NOC Application/Permit Revision/AOP Off-Permit Change Notification

Project Title: Radioactive Air Emission Notice of Construction Fuel Removal for 105-KW Basin

Current NOC Application Number: DOE/RL-97-28, Rev. 2

Provides updates to Section 9.0 and replaces Figure 9-2.

Figure 9-2. Locations of Ambient Air Near FacilityField Monitoring LocationsStations.

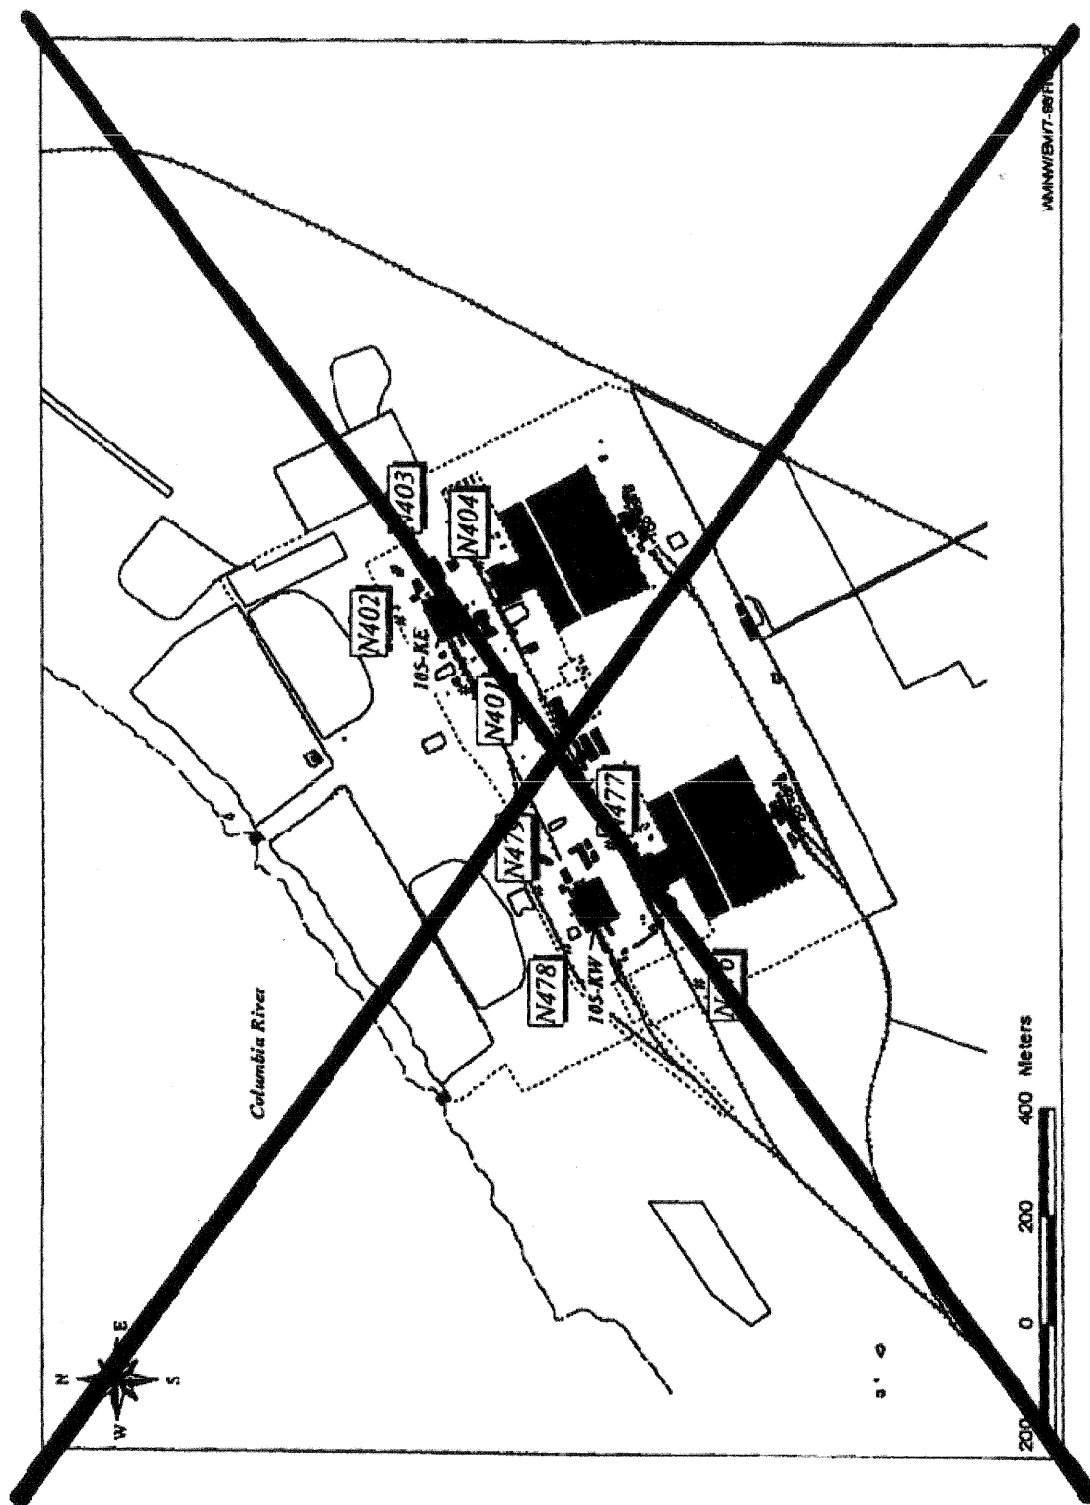
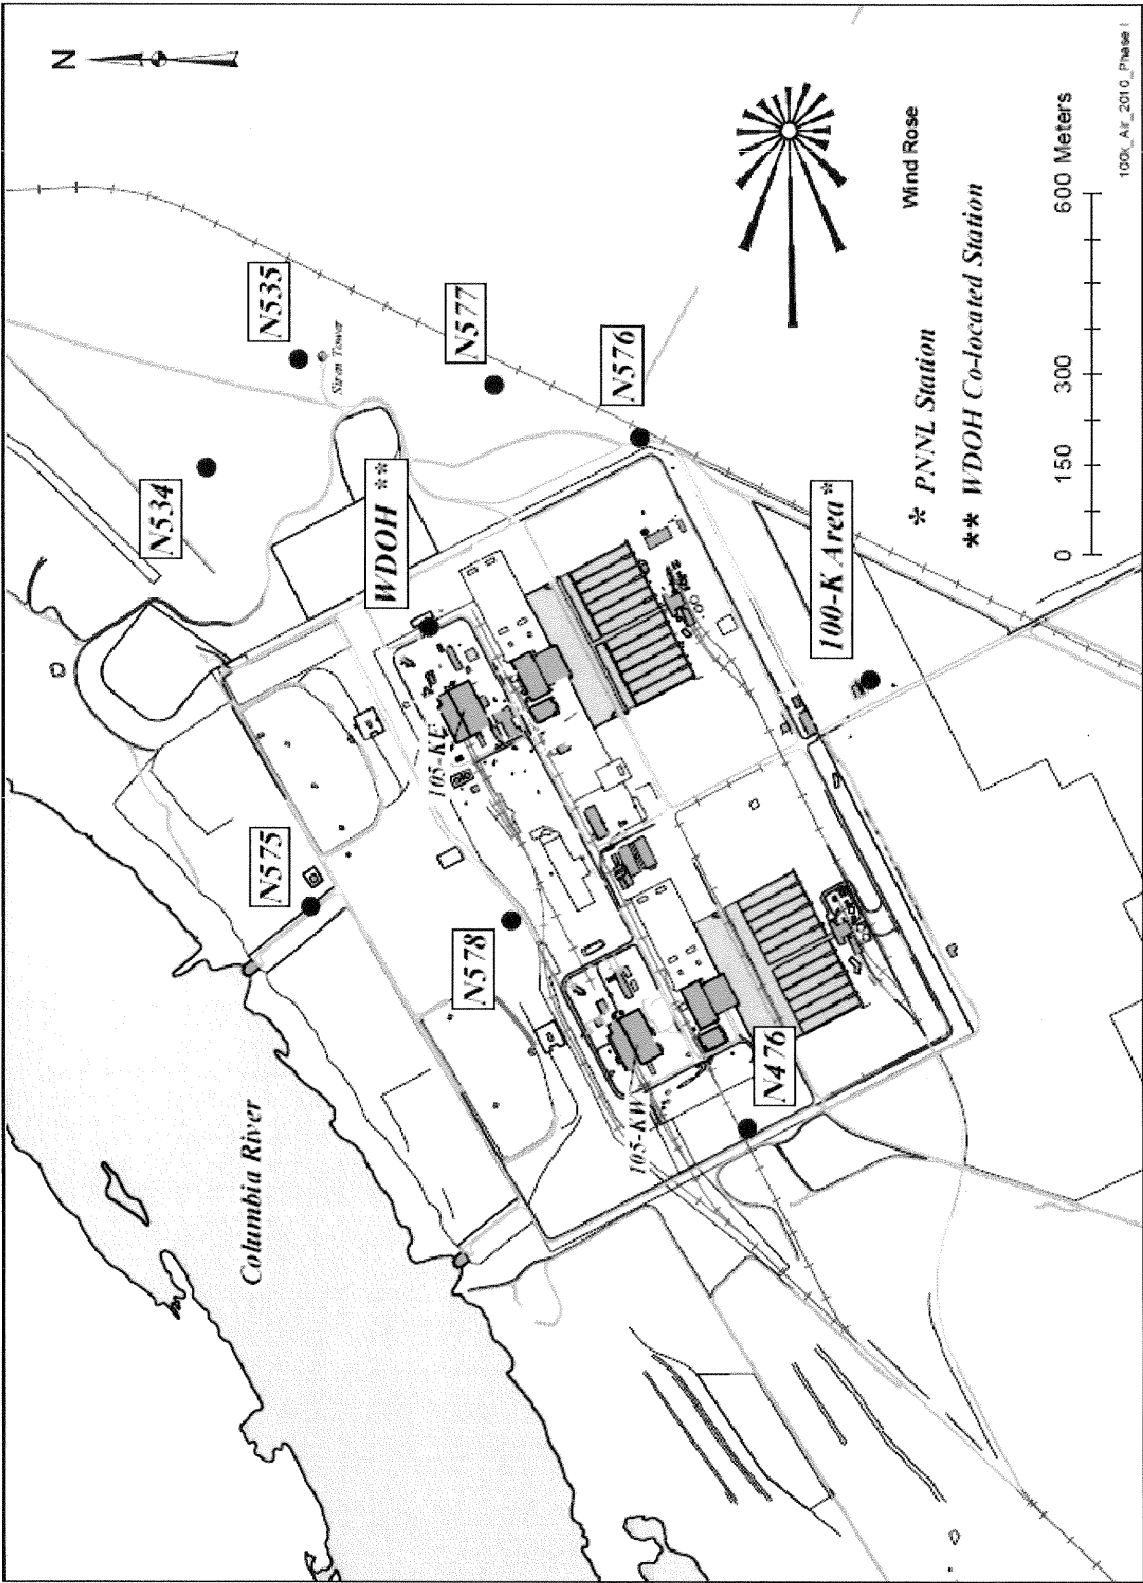
Ambient air monitors currently supporting the 100K CERCLA remedial action have been determined to merit relocation to support ongoing and future facility demolition and soil remediation activities. An analysis was performed to determine the requisite number of ambient air monitors needed to adequately support the remedial action. Using the combined area of the 100K Area activities as the source of fugitive/diffuse emissions, ambient air monitors were placed in an arc configuration approximately 500 meters out, taking into consideration such parameters as the potential impact of primary activities, potential source terms, prevailing wind directions, topography of the area, and dispersion coefficients. The proposed number and locations for ambient air monitor placements have been confirmed as providing adequate coverage.

In addition to the system described previously, ~~near-field~~near-facility ambient air monitoring currently is being performed and will continue at several locations in the 100-K Area around the 105-KW Basin. ~~This near field ambient air monitoring network is comprised of four monitors, designated as N-476, 477, 478, and 479. Figure 9-2 shows the current locations of the four ambient air monitors.~~

Near-facility monitoring is performed in the 105-KE/105-KW locale as part of the Hanford Site Near-Facility Monitoring Program, described in the Environmental Monitoring Plan (DOE/RL-91-50, latest revision), to monitor ambient air quality as may be impacted by localized fugitive/diffuse radionuclide emissions. This existing network of near-facility ambient air monitoring stations is maintained in the 100-K Area to address U.S. DOE requirements (as described in the referenced plan) which are separate from requirements under this remedial action. The latest Near-Facility Monitoring Program direction is to replace the 8 currently operating ambient air monitoring stations very near the 105-KE/105-KW Reactor Facilities and Ancillary Facilities with a perimeter of 6 new stations, each within a radius of roughly 500m from the footprint of the combined facilities. One existing ambient air monitoring station operated by PNNL and within the 500m arc will also provide data utilized for the Near-Facility Monitoring Program. In addition to the near-facility monitors, one ambient air monitor will be added east of the 105-KW Building for specific coverage of 105-KW Basin Operations. While additional adjustment in the number or location of near-facility monitoring stations may occur to support the Near-Facility Monitoring Program, it will be assured that no less than three 100-K Area near-facility monitoring stations will remain within the 100-K Area as part of the Near-Facility Monitoring Program during completion of the Remedial Action Work for the 105-KW Basin. Locations of the near-facility monitors and the additional ambient air monitor are shown in Figure 9-2.
